MODIFICATION REQUEST:

***Clemton Park Village, 60 Charlotte Street,
Campsie
Former Sunbeam Factory
Concept Plan MP07_0106 MOD 5***

Secretary's Environmental Assessment Report
Section 75W of the
Environmental Planning and Assessment Act 1979

June 2014

Figure 2: Lot 31 Approved Layout

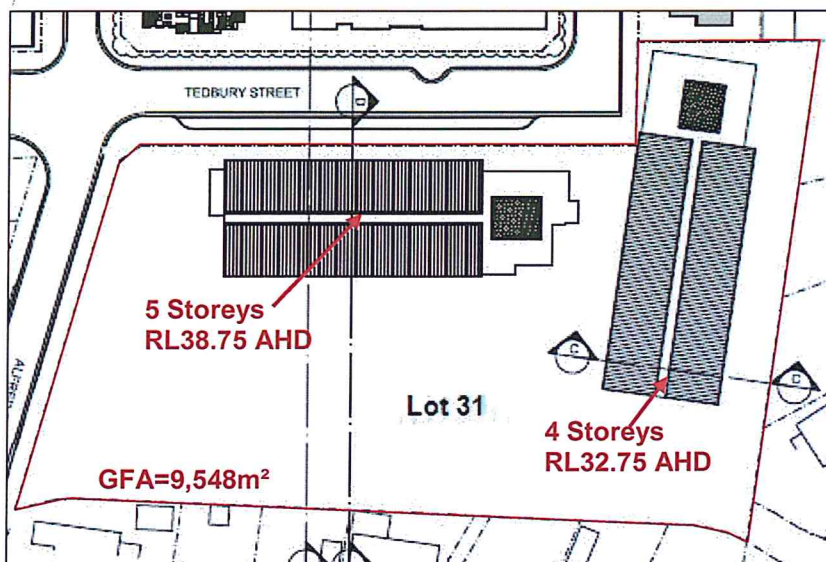
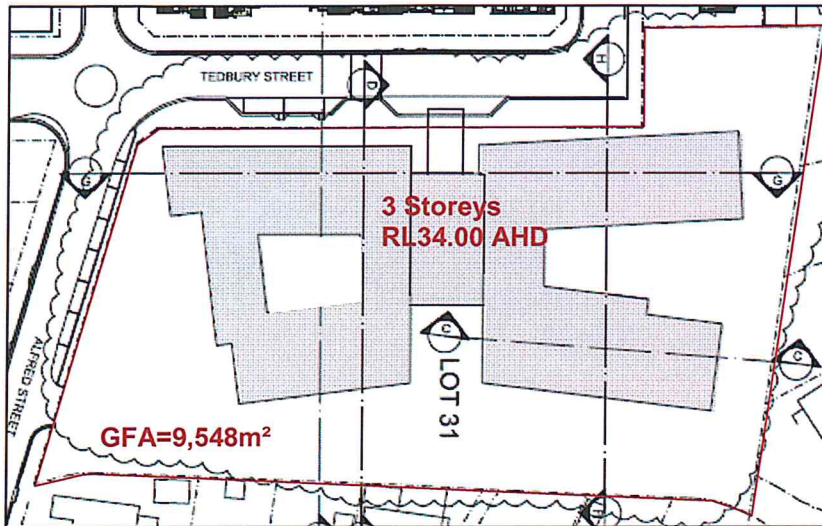
- amend building envelopes on Lot 31, replacing the approved 2, 4-6 storey building envelopes with a single building envelope (having a larger footprint) with a height reduced to 3 storeys.
- relocate the vehicular entrance from Tedbury Street (north) to Alfred Street (west); and
- amend the Statement of Commitments to reflect updated traffic and flooding reports submitted with this application.

The approved and proposed layout for Lot 31 is shown in **Figures 2 and 3** below.

Figure 4: Extract from indicative landscape plan

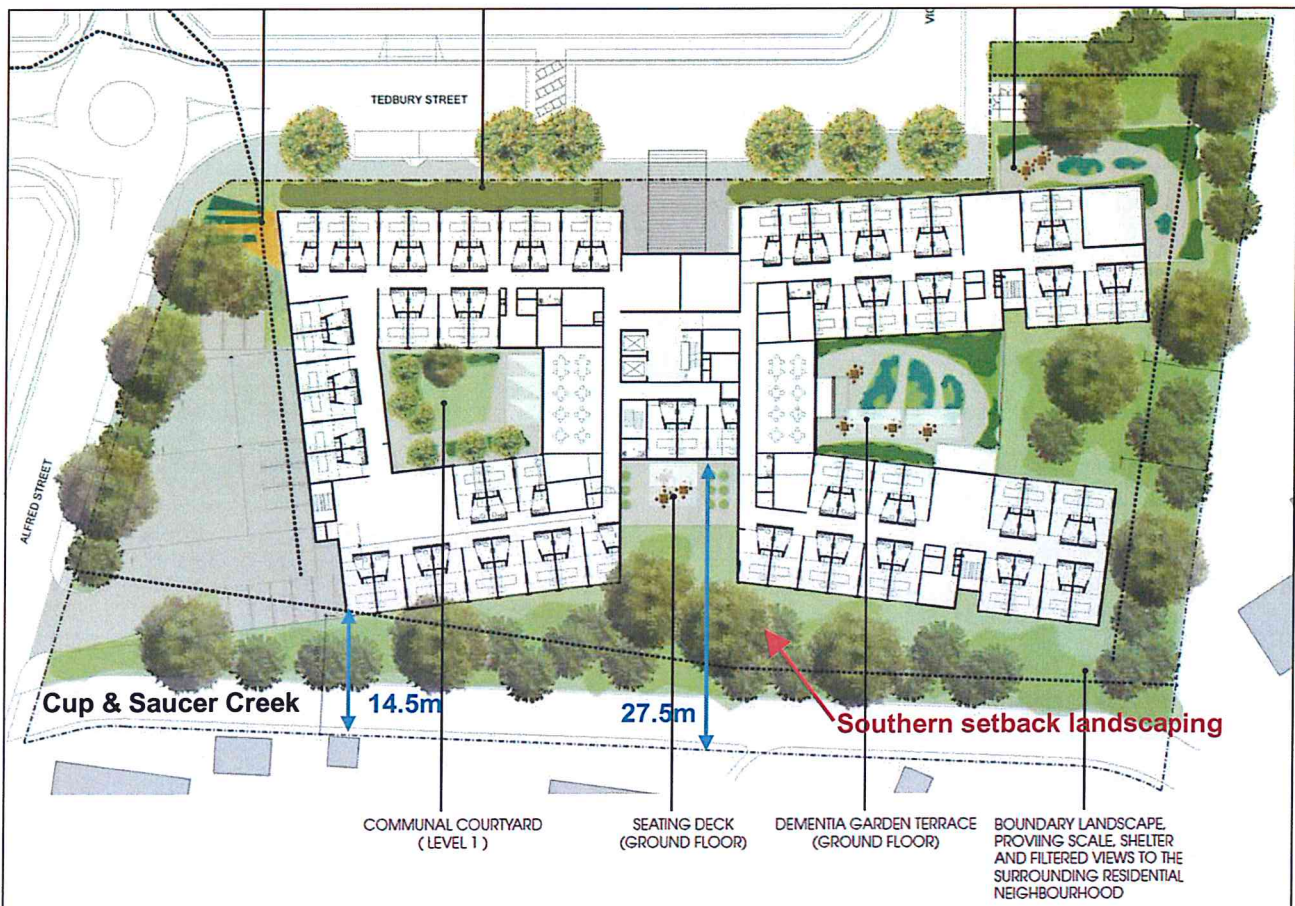
The proposal also seeks to reduce the setback to the southern boundary. The existing approved envelopes were located between 22 to 40 metres away from the southern boundary. The proposal involves a reduced setback ranging between 14.5m to 27.5m (refer to **Figure 4**).

Residents in Reid Avenue raised concern in relation to the impact of the reduced setback of the proposal to the southern boundary. In particular, concerns were raised with regard to:

- adverse overshadowing impacts;
- privacy and overlooking impacts; and
- overbearing and visual bulk impacts.

Although the building will be closer to the boundary than previously approved, it is considered that the significant reduction in height will also result in an overall improvement in visual impacts at the boundaries. The building design has been articulated, with deep recesses to reduce the appearance of bulk and scale along the Tedbury Street frontage and the rear aspect facing Reid Avenue. The Department also notes that the setbacks provide ample room for dense landscaping to screen the proposed development (refer to indicative landscape plan in **Figure 4**). This matter can be further addressed at the detailed DA stage with Council.

Flooding was a key issue addressed in the Department's assessment of the Concept Plan. Lot 31 has a storm water culvert located along the southern boundary (refer to **Figure 4**). The original buildings were located clear from the flood zone, however the proposed modification involves building envelope within the potential flood zone. The proponent's flood report advises that the highest 100 year flood level in proximity to the site is 21.3m AHD at the corner of Harp and Alfred Streets.

The Department notes that despite a reduction in setbacks, the proposal still comfortably complies with Council's DCP which requires a setback of 4 or 6 metres from the side and rear boundaries respectively.

In terms of privacy, the Department notes that the reduced height of the development will result in fewer opportunities for overlooking. The minimum 14.5 metre setback provides an adequate space for dense landscaping to screen the development and maintain the privacy of adjoining dwellings. In addition, this matter can be further considered by Council in the future assessment of a DA for the development.

The proposed changes to the built form are therefore considered to be appropriate.
